Pentium® Pro Processor Specification Update

Release Date: November 1997

Order Number: 242689-022

The Pentium® Pro processor may contain design defects or errors known as errata which may cause the product to deviate from published specifications. Current characterized errata are documented in this Specification Update.

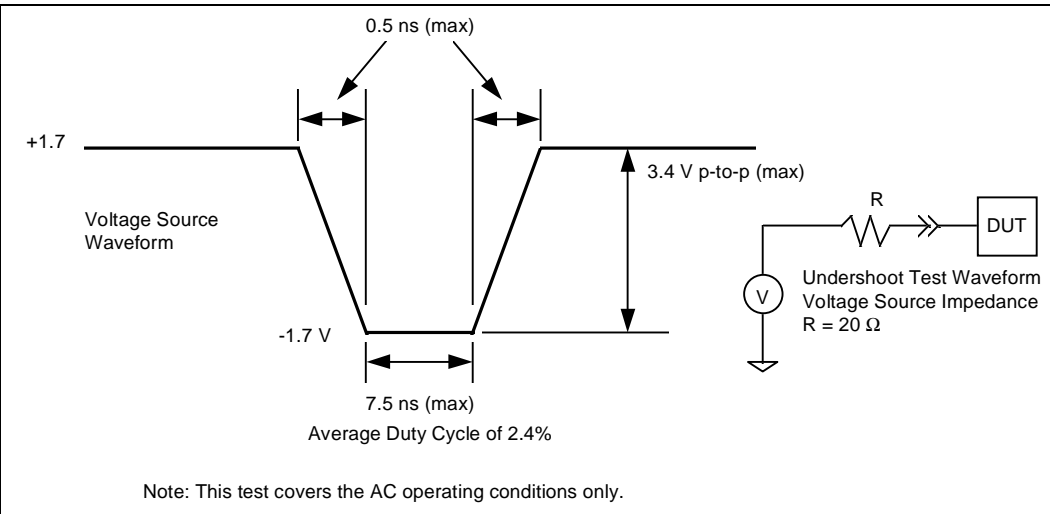
The following list and matrix explain the known issues with mixing steppings:

- While Intel has done nothing to prevent different frequency Pentium® Pro processors within a system from working together, there may be uncharacterized errata which exist in such configurations. In mixed stepping systems, all processors must be run at an identical frequency (i.e., the *highest* frequency acceptable to all components).

- The workarounds for various errata must take all processors into account.
- Errata for all processor steppings present in a system will affect that system, unless worked around.

- The following notes apply only to specific combinations:
 1. The 150-MHz and the 166-, 180-, and 200-MHz parts vary in their GTL+ T_{CO_MIN} and T_{HOLD} timings by 250 ps. This may affect some system designs. Also, a customer may wish to use a higher frequency replacement for a 150-MHz processor in a 150-MHz system; this should also be considered.

2. OverDrive® processor upgrades for the Pentium Pro processor will only be supported in one and two processor systems, and are only supported in same stepping configurations.

3. Errata numbers 39 and 41 may be problematic for 3- or 4-way MP systems which use processor steppings previous to the sA1 stepping.

In the following table, "NI" implies that there are currently no known issues associated with mixing these steppings. An "X" implies that these steppings should not be used together in a system. A number indicates a known issue, and refers to the numbered list above. There are no currently known issues associated with mixing cache sizes.

B. Expected Response

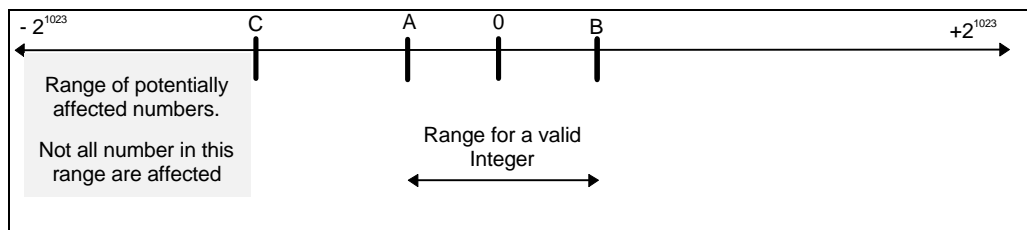
PROBLEM: On certain, large, negative, floating-point operands, and only in three of the four possible processor rounding modes, the instructions FIST[P] m16int and FIST[P] m32int do not detect that the operand is so large that it will not fit into the target data size. As a consequence, the expected Invalid Operation exception response for this

- Return the MAXNEG value (8000h for FIST16 & 80000000h for FIST32) to memory.
- The IE (Invalid Operation) bit in the Floating Point status word is *not set* to flag the use of an invalid operand.
- The PE (precision error) bit the Floating Point status word is *set*.
- No exception handler is invoked.
- In the case of a FISTP instruction the Operand will have been popped from the floating point stack.

The expected processor response when the invalid operation exception is *masked* is:

- Return the MAXNEG value (8000h for FIST16 & 80000000h for FIST32) to memory.
- The IE (Invalid Operation) bit in the Floating Point status word is *set* to flag the overflow.
- The PE (precision error) bit the Floating Point status word is *not set*.

Figure 4-3. Stack Switch on a Call to a Different Privilege Level

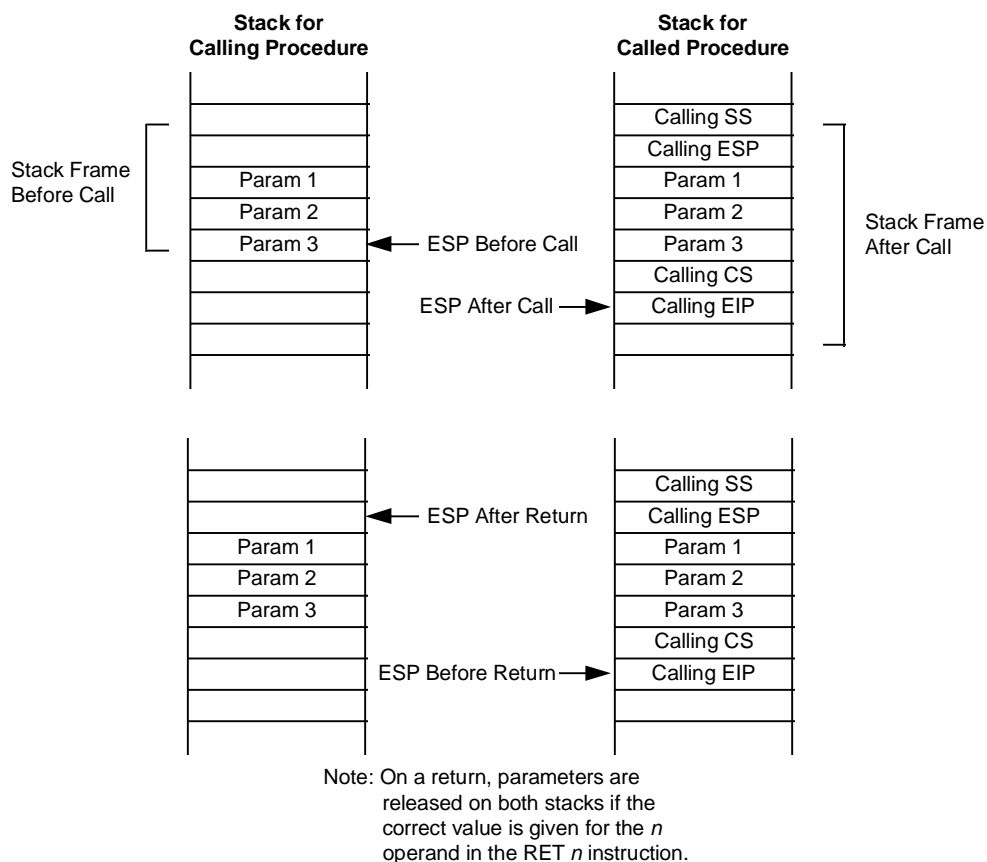
When making a call to a more privileged protection level, the processor does the following (see Figure 4-3):

3. (If the RET instruction has an optional *n* argument.) Increments the stack pointer by the number of bytes specified with the *n* operand to release parameters from the stack. If the call gate descriptor specifies that one or more parameters be copied from one stack to the other, a RET *n* instruction must be used to release the parameters from both stacks. Here, the *n* operand specifies the number of bytes occupied on each stack by the parameters. On a return, the processor increments ESP by *n* for each stack to step over (effectively remove) these parameters from the stacks.

4. Restores the SS and ESP registers to their values prior to the call, which causes a switch back to the stack of the calling procedure.
5. (If the RET instruction has an optional *n* argument.) Increments the stack pointer by the number of bytes specified with the *n* operand to release parameters from the stack (see explanation in step 3).

Figure 4-4. Stack Usage on Transfers to Interrupt and Exception Handling Routines

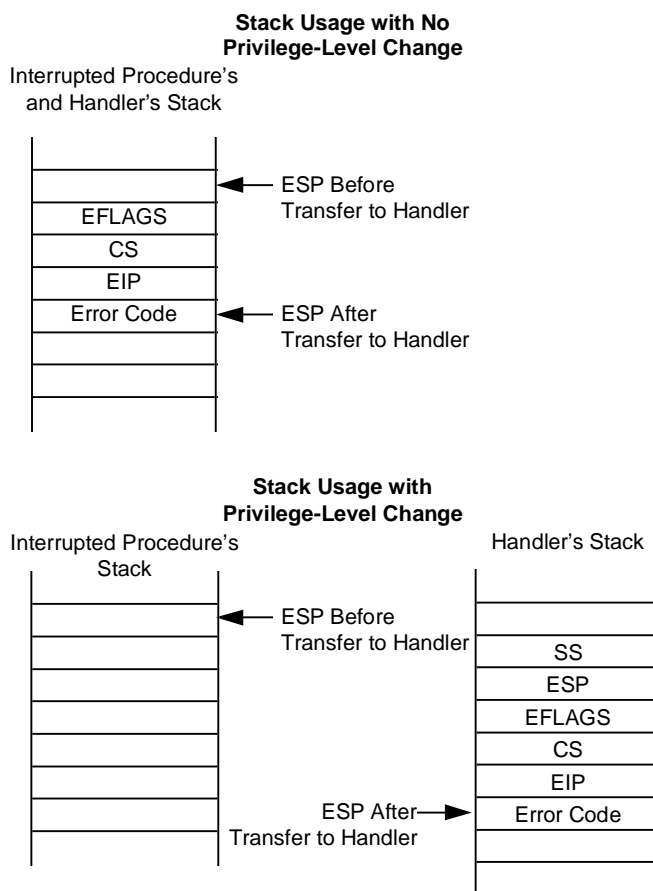
If no stack switch occurs, the processor does the following when calling an interrupt or exception handler (see Figure 44):

When executing a return from an interrupt or exception handler from a different privilege level than the interrupted procedure, the processor performs these actions:

1. Performs a privilege check.
2. Restores the CS and EIP registers to their values prior to the interrupt or exception.
3. Restores the EFLAGS register.
4. Restores the SS and ESP registers to their values prior to the interrupt or exception, resulting in a stack switch back to the stack of the interrupted procedure.
5. Resumes execution of the interrupted procedure.
